AMENDMENTS TO THE DRAWINGS:

FIG. 6

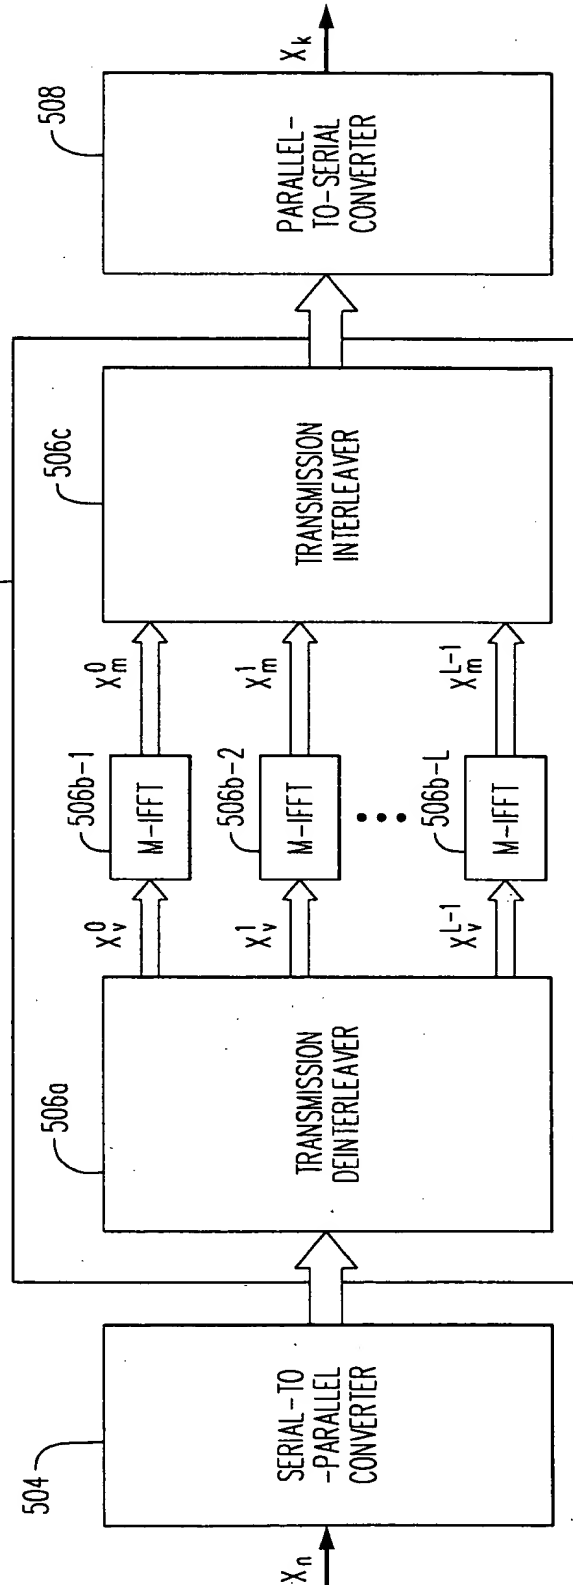
The attached sheets of drawings include changes to Figures 6 and 16. These sheets, which include Figures 5, 6, and 16, replace the original sheets including Figures 5, 6, and 16. In Figure 6, the N-IFFT in each of 506b-1 to 506b-L is replaced with a M-IFFT, and in Figure 16, the N-FFT in each of 1522b-1 to 1522b-L is replaced with a M-FFT.
